PROJECT BRIEF

Historic District Board of Review Application for Certificate of Appropriateness at 407 E. Vaughn Dr. to build top floor addition on north side of structure.

Application Date: August 29, 2023 (extended twice)
HDBR Meeting Date: November 27, 2023

Sheet No. **A101**

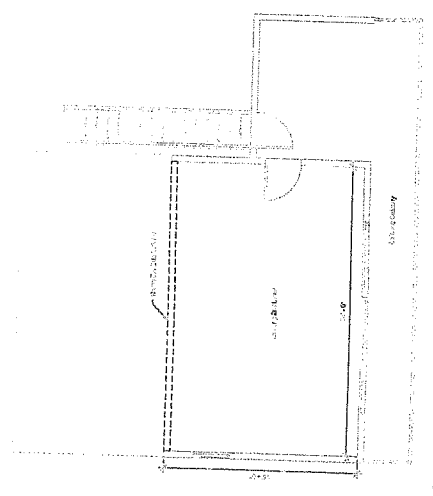
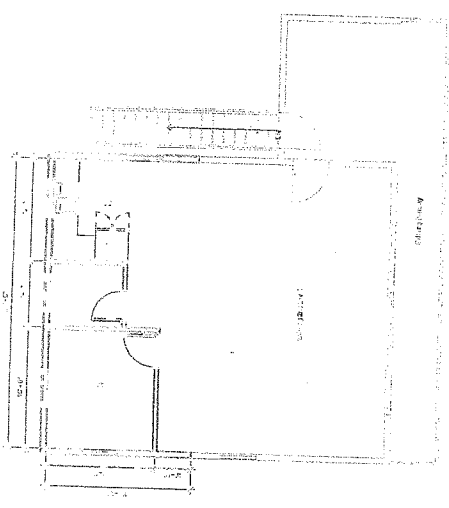
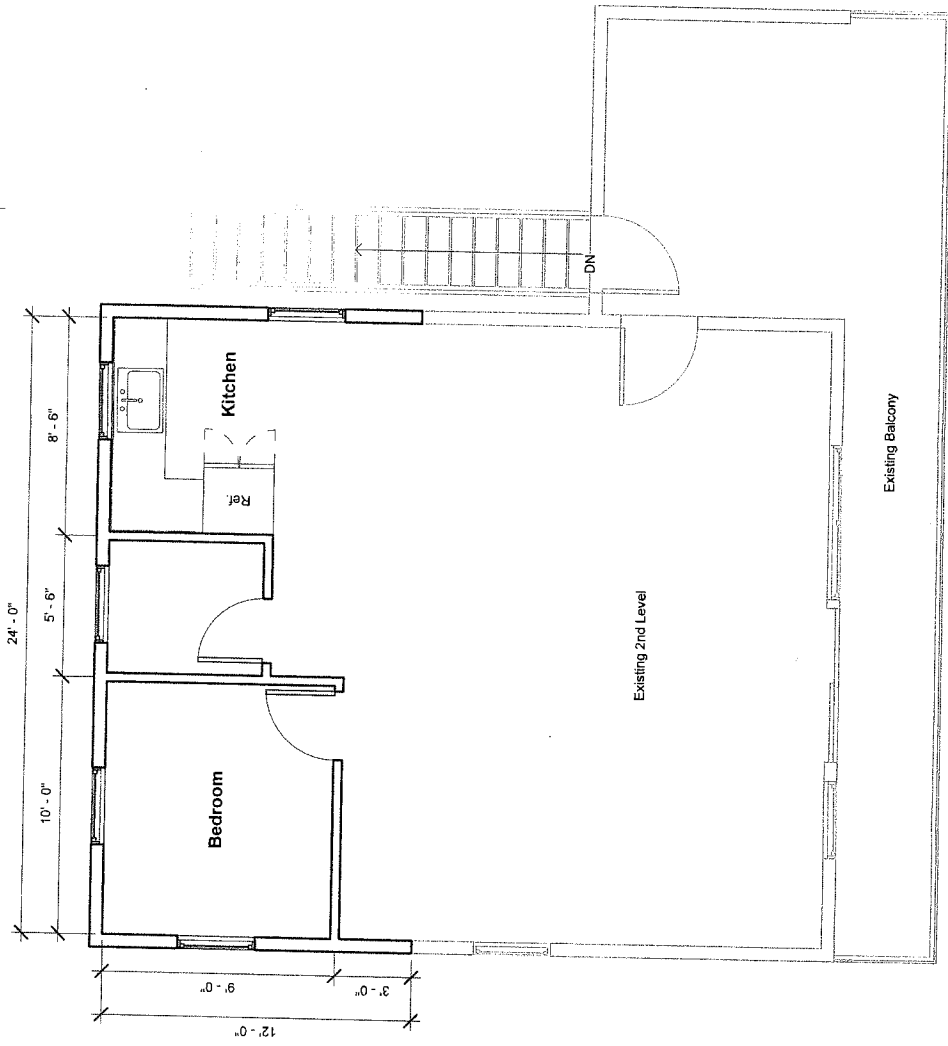
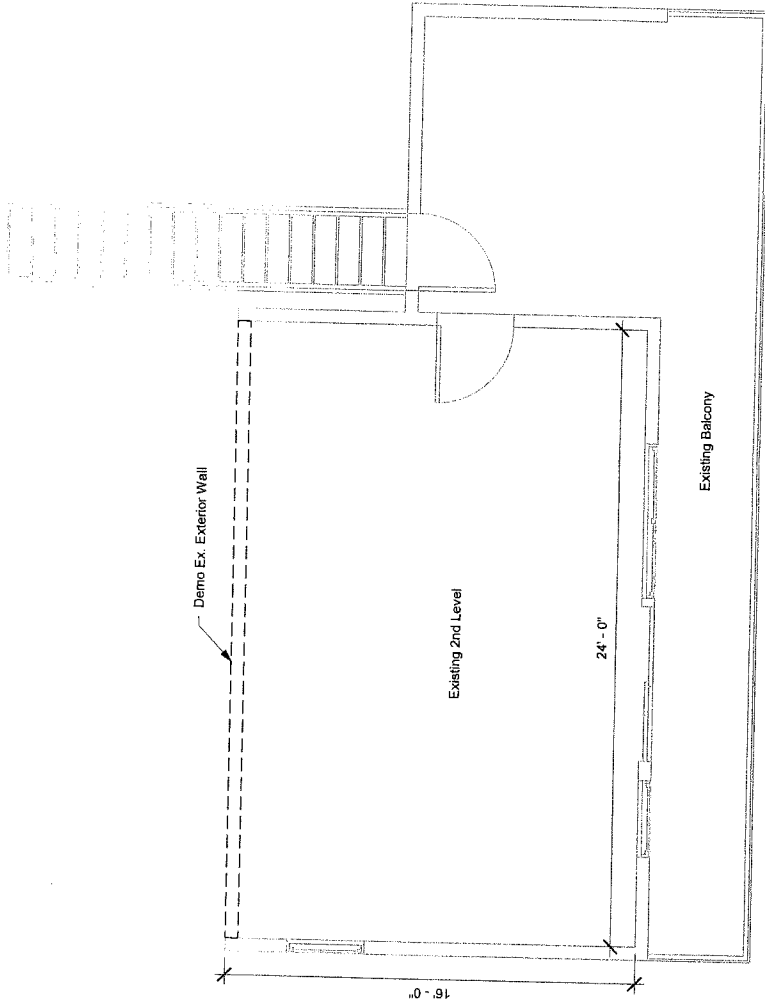
The project *is in* conformance with Guideline 26.1 because the proposed new addition will be placed on the north but is *not in* conformance because the addition will affect a primary façade [this structure is located on a highly visible corner, so all sides are highly visible; however, given its status as a non-contributing structure, the addition will not have any impact upon the designation rating]; *is in* conformance with Guideline 26.2-26.3 because the proposed addition is of the appropriate massing in relation to the existing structure and the new materials will match existing materials; is *not in* conformance with Guideline 26.4 because the new addition will require the demolition of the entire north wall [unknown if the north wall is a historic original wall or contemporary wall]; *is in* conformance with 26.6-26.9 because the new windows will match the existing windows, the foundation will be the same or compatible to the existing, and prior alterations/additions have been considered and factored in to the design of the proposed new addition; *is in* conformance with the Ordinance because the proposed materials and addition will be visually compatible with the existing structure; and is *not in*

conformance with SOI for Rehabilitation because the proposed alterations involve more than minimal exterior visual change.
